## **LiDAR Quality Assessment Report**

Materials Received:	Project Type: NSDI Agreement
4/2/2013	Тојесстурс.
	Project Description:
Project ID:	Delivery of remainder of project area.
AK_MatanuskaSusitna-Lot2_2012	
Project Alias(es):	Year of Collection: 2012
MatSu	
Lot 2 of 2 lots.

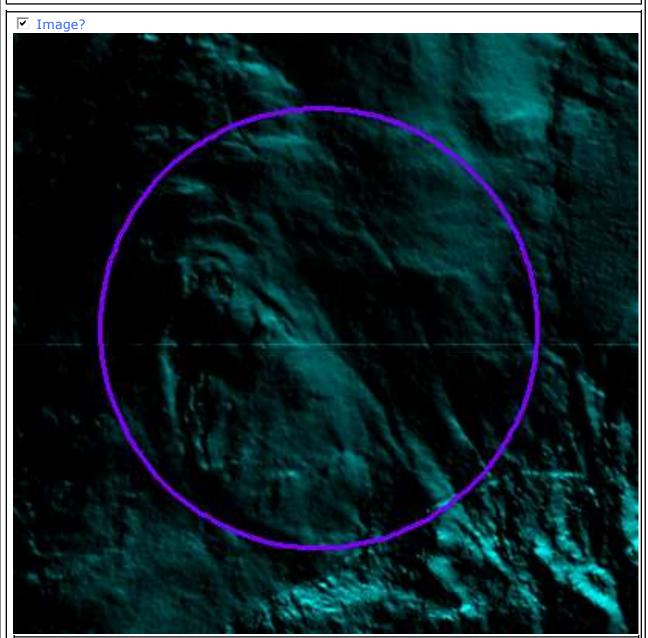
Several tiling artifacts observed throughout delivered bare-earth DEMs. Acceptable. Reviewer at NGTOC created a shapefile documenting examples of errors and/or anomalies found during review. The shapefile is named errors.shp and does not include all errors identified during review, rather, the shapefile provides at least one example of each type of error identified in the delivered bare-earth DEMs.

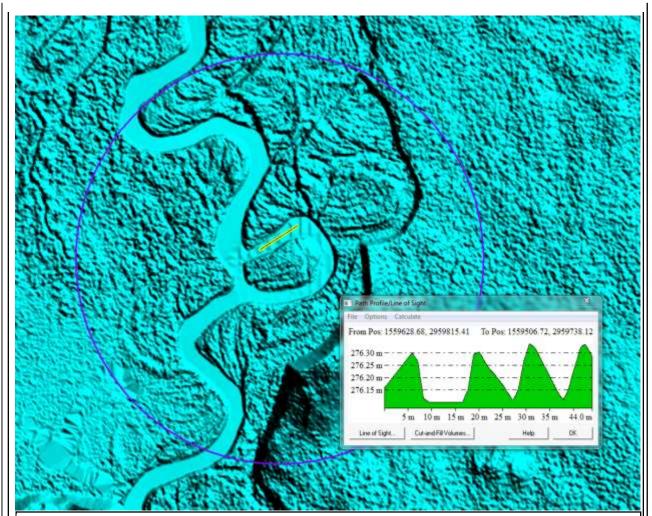
Double line stream does not maintain downstream constraint. This was observed by the reviewer throughout the delivered DEMs. Reviewer at NGTOC created a shapefile documenting examples of errors and/or anomalies found during review. The shapefile is named errors.shp and does not include all errors identified during review, rather, the shapefile provides at least one example of each type of error identified in the delivered bare-earth DEMs.

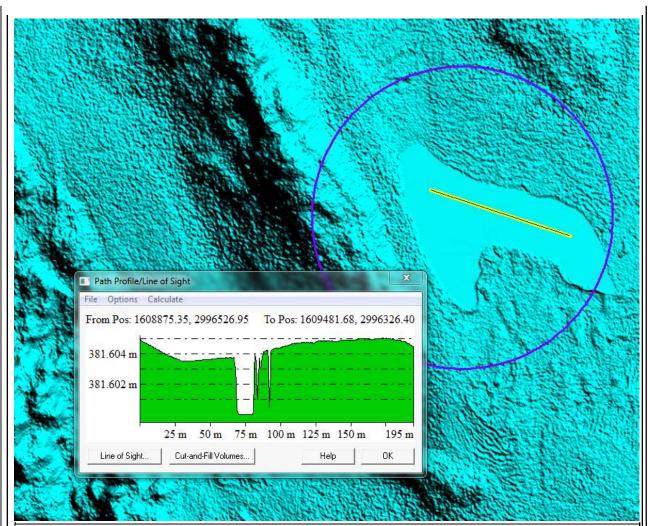
Waterbody greater than 2 acres in area not correctly hydroflattened. This was observed by the reviewer throughout the delivered DEMs. Reviewer at NGTOC created a shapefile documenting examples of errors and/or anomalies found during review. The shapefile is named errors.shp and does not include all errors identified during review, rather, the shapefile provides at least one example of each type of error identified in the delivered bare-earth DEMs.

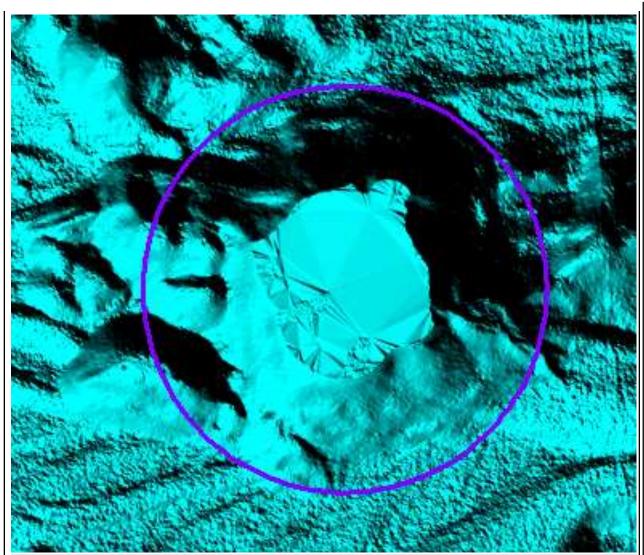
Waterbody greater than 2 acres in area not hydroflattened. No breaklines associated with waterbody. This was observed by the reviewer throughout the delivered DEMs. Reviewer at NGTOC created a shapefile documenting examples of errors and/or anomalies found during review. The shapefile is named errors.shp and does not include all errors identified during review, rather, the shapefile provides at least one example of each type of error identified in the delivered bare-earth DEMs.

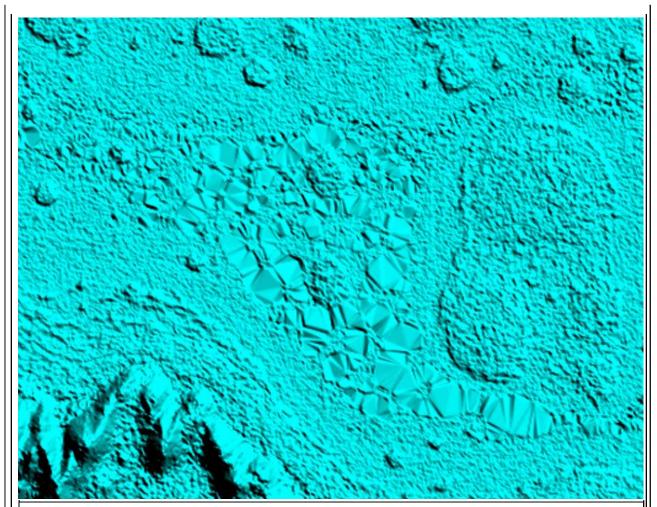
Extreme tinning observed throughout the bare-earth surface. Reviewer at NGTOC created a shapefile documenting examples of errors and/or anomalies found during review. The shapefile is named errors.shp and does not include all errors identified during review, rather, the shapefile provides at least one example of each type of error identified in the delivered bare-earth DEMs.

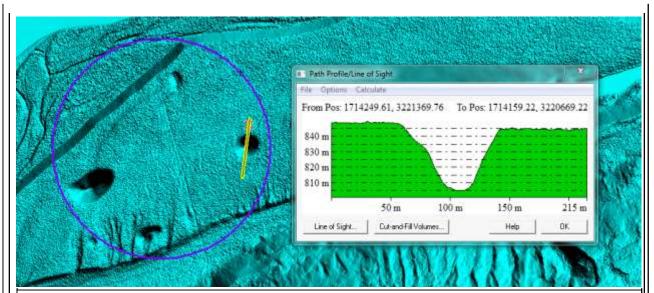
Pits in bare earth surface. Reviewer at NGTOC created a shapefile documenting examples of errors and/or anomalies found during review. The shapefile is named errors.shp and does not include all errors identified during review, rather, the shapefile provides at least one example of each type of error identified in the delivered bare-earth DEMs.
